Sag Harbor

SUITE 518
INVENTORY SUITE
ORIGINAL SUITE
LAYOUT

SUITE 518 - INVENT SUITE

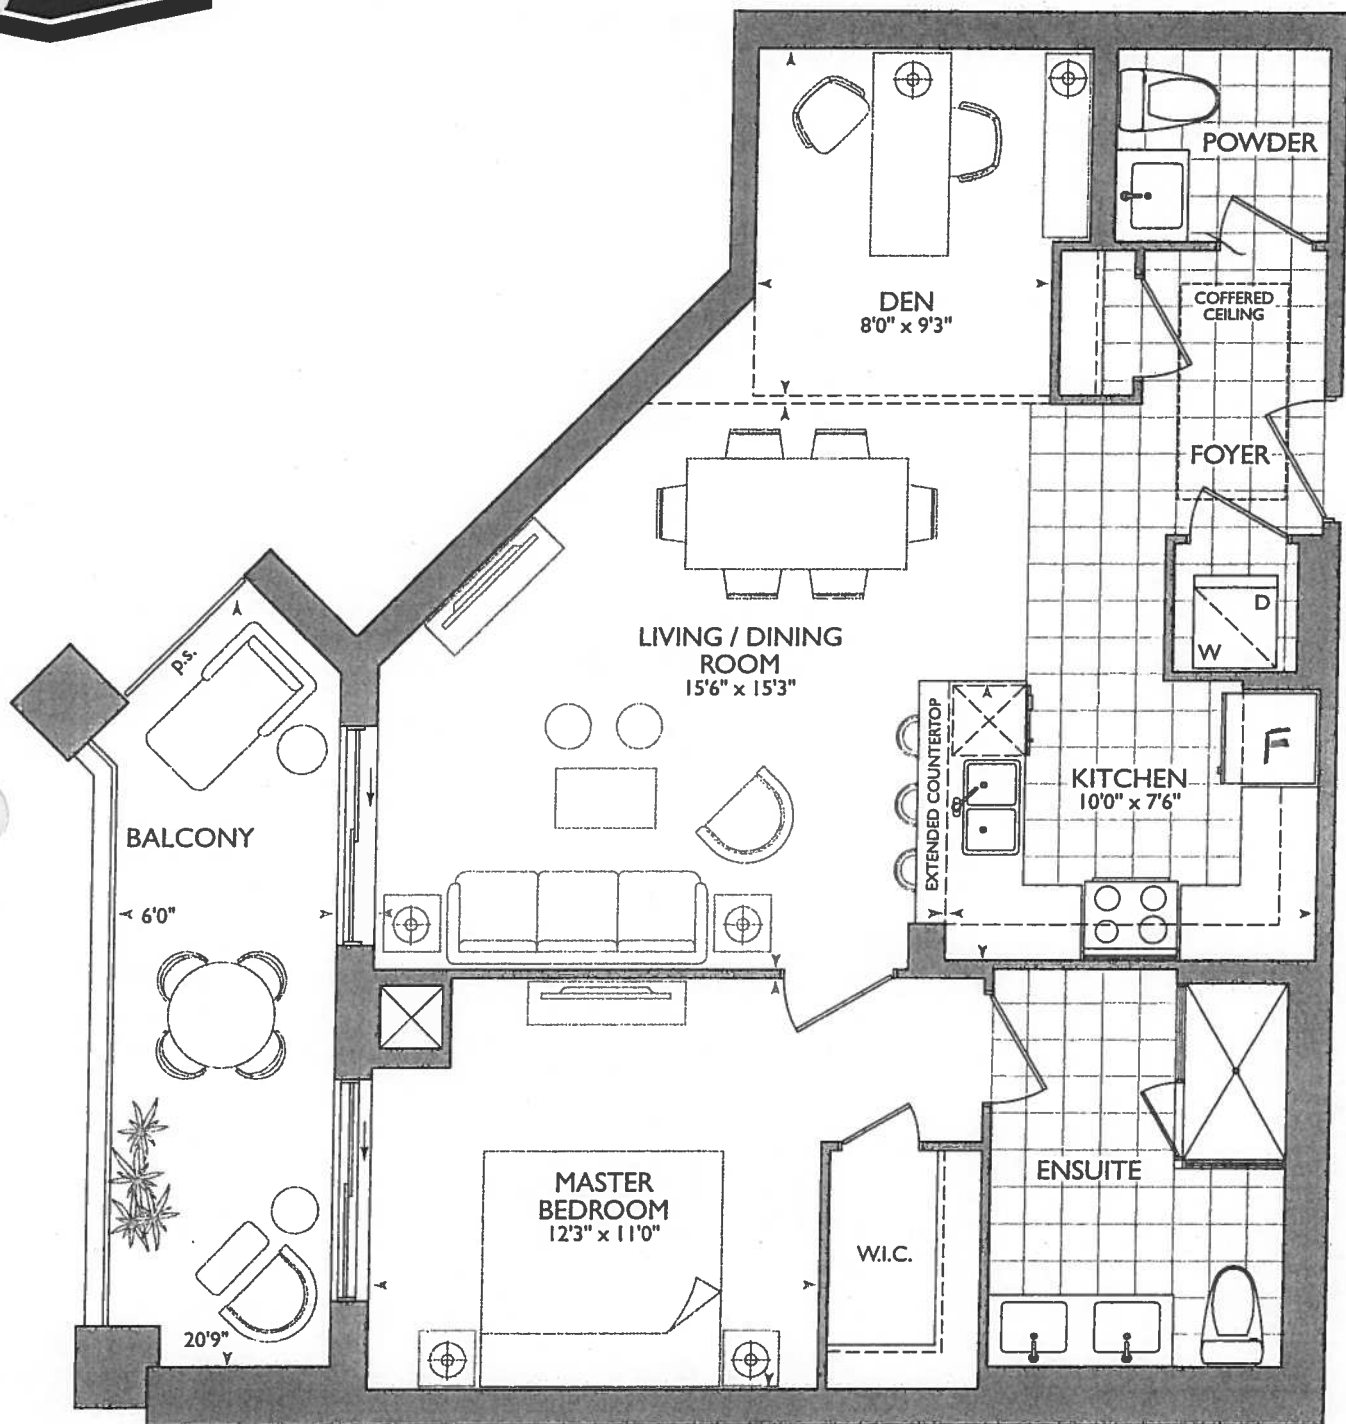
* SHIFT FRONT ENTRY DOOR
TOWARDS POWDER ROOM DUE
TO 6" WALL BEHIND WASH/DRYER

KITCHEN

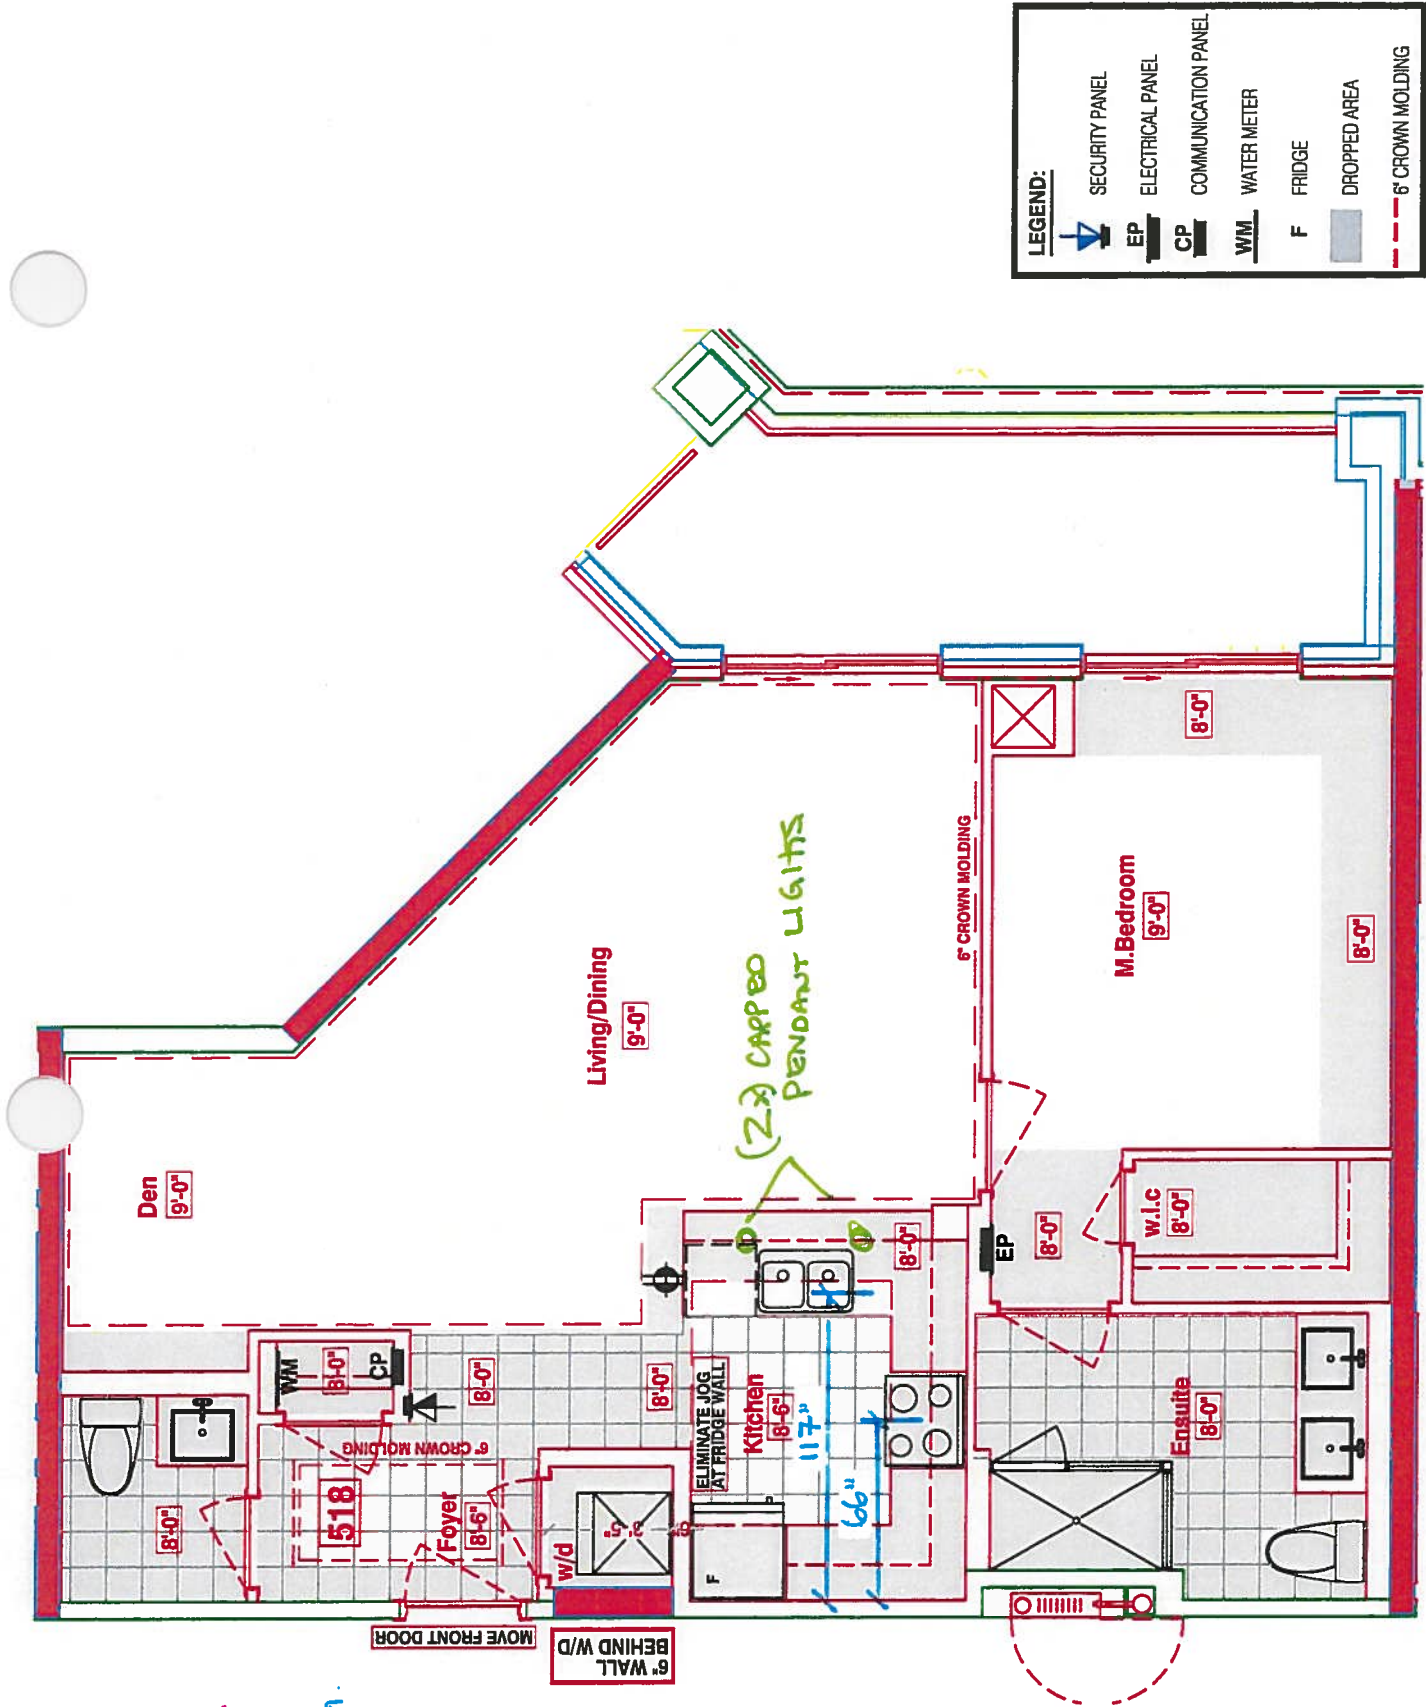
- STD KITCHEN W/ STD APPLIANCE PKG.
- (x1) = PLUG PENINSULA
- (x2) = CAPPED PENDANT LIGHTS
OVER PENINSULA
- (x3) = PUCK LIGHTS.
- 66" STOVE PIPE CENTER
- 117" SINK PIPE CENTER

- 1ST UPGRADE KITCHEN LAYOUT
- 1ST UPGRADE APPLIANCE PKG
- SEE UPGRADE KITCHEN
LAYOUT FOR ALL EXTRAS

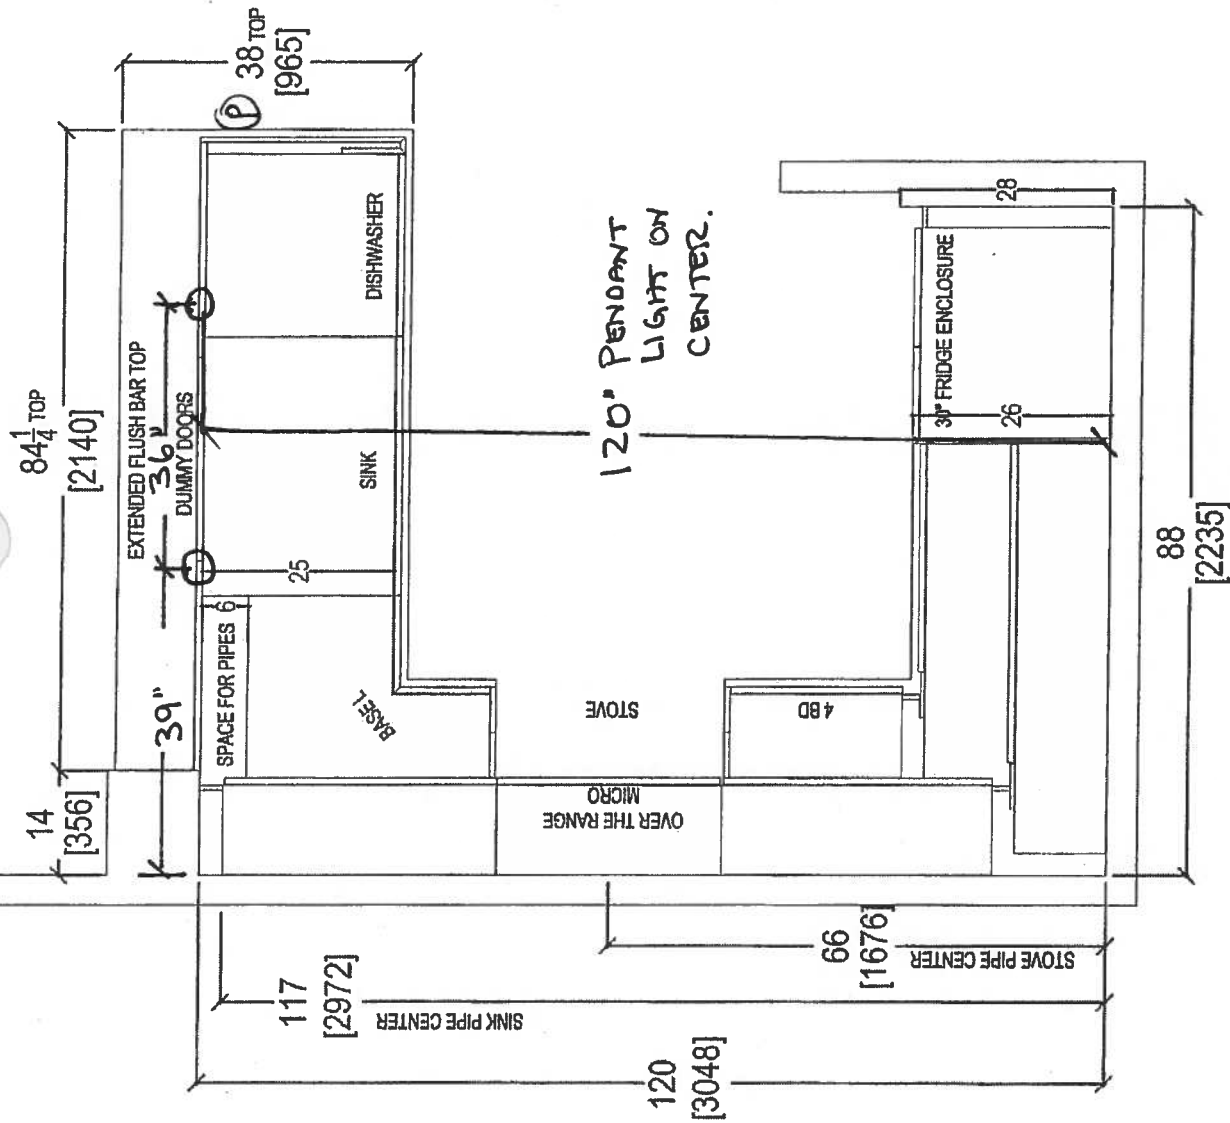
- 518- INVENTORY SUMME
- STD KITCHEN LAYOUT
 - STD APPLIANCE PKGS.
 - (x1) - PLUG PENINSULA
 - (x2) - CARPES PENDANT LIGHTS
 - (x3) - RUCK LIGHTS

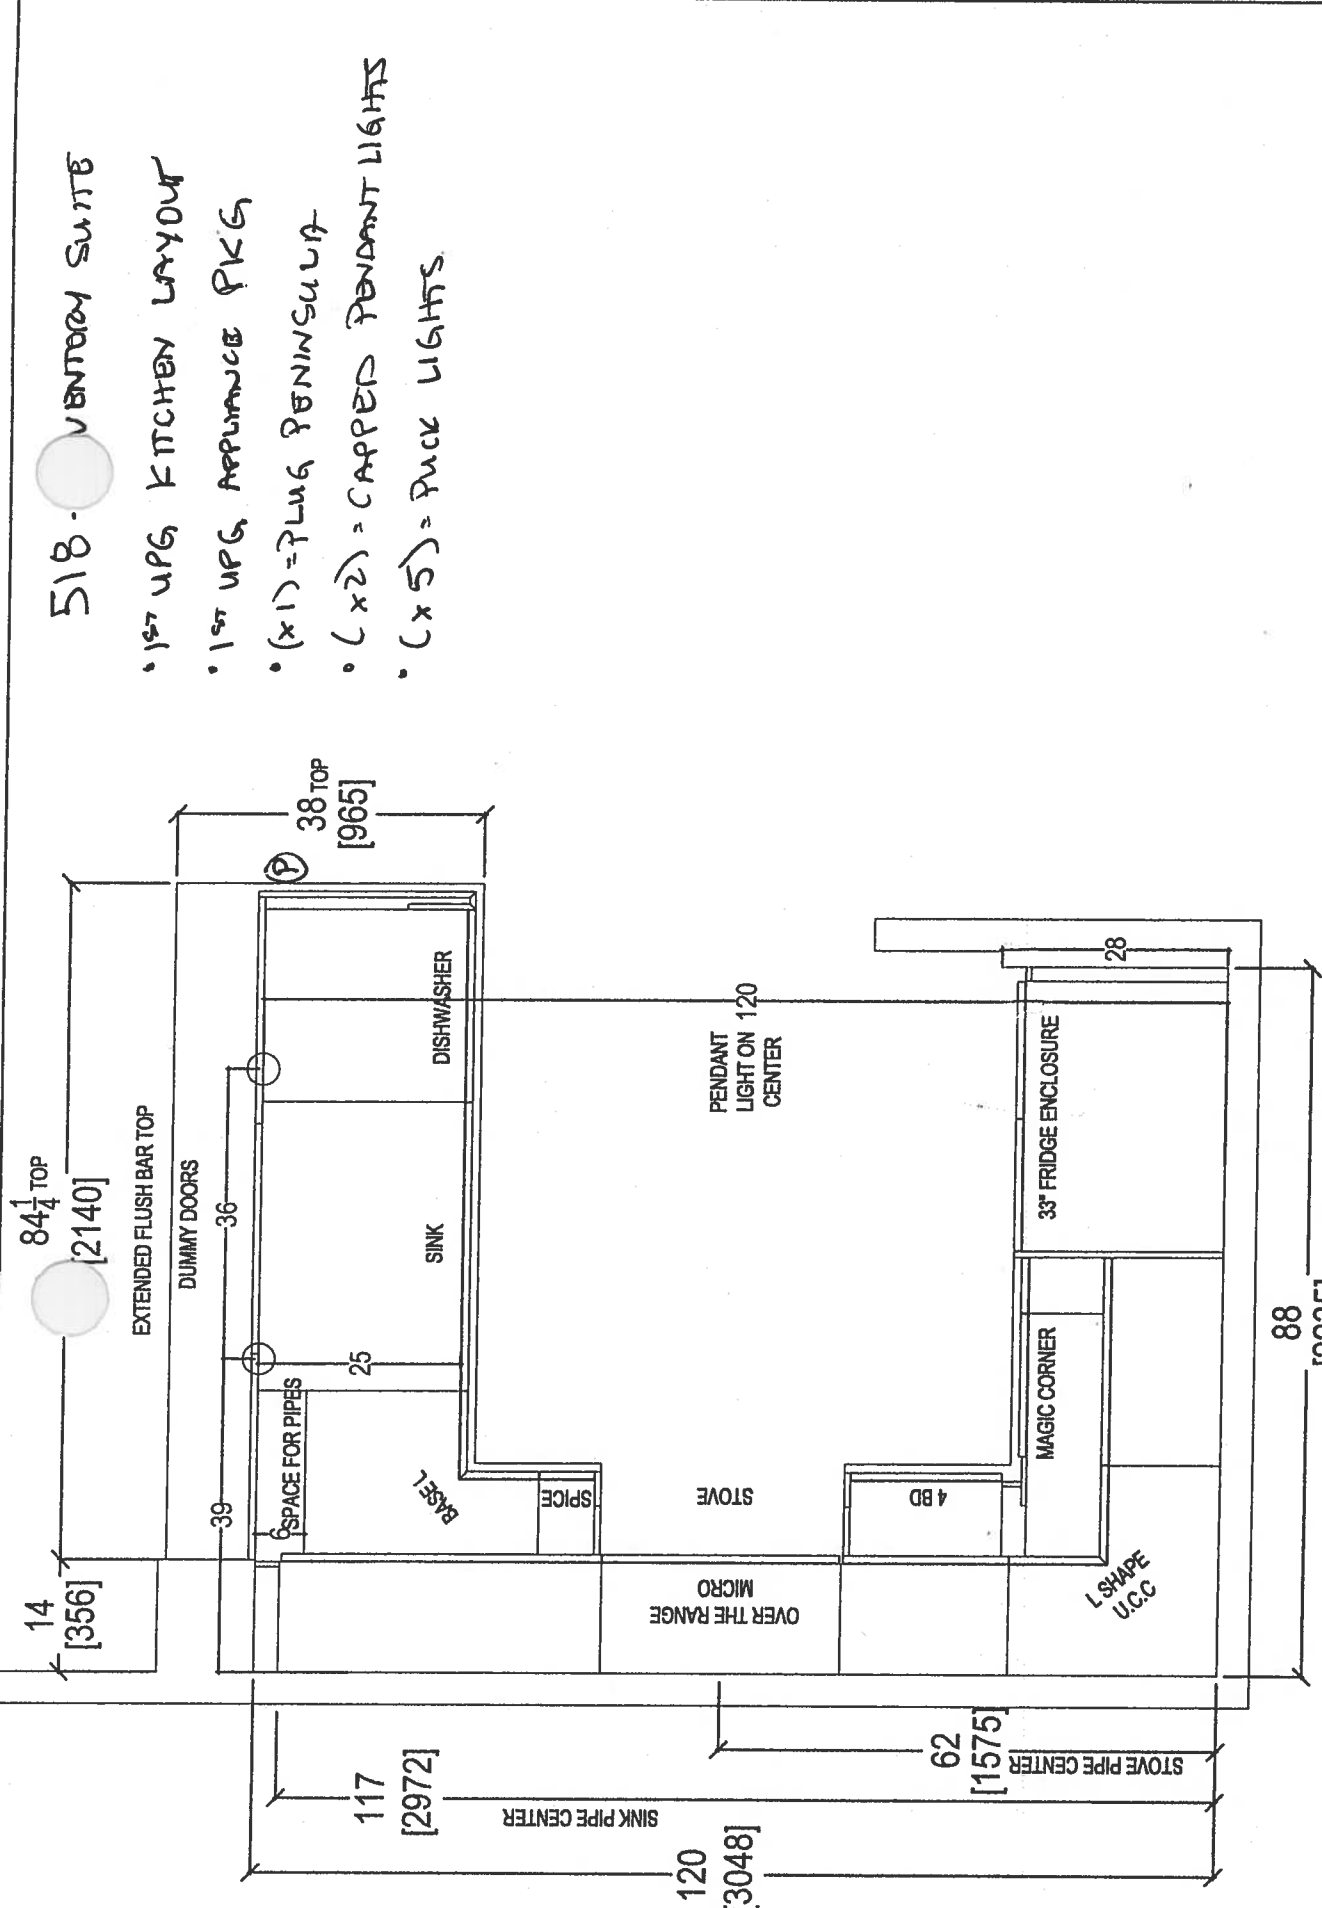
- 518 - VENTURA SUITE
- 1st UPG KITCHEN LAYOUT
 - 1st UPG APPLIANCE PKGS
 - (x1) = PLUG PENINSULA
 - (x2) = CAPPED PENDANT LIGHTS
 - (x5) = RUCK LIGHTS
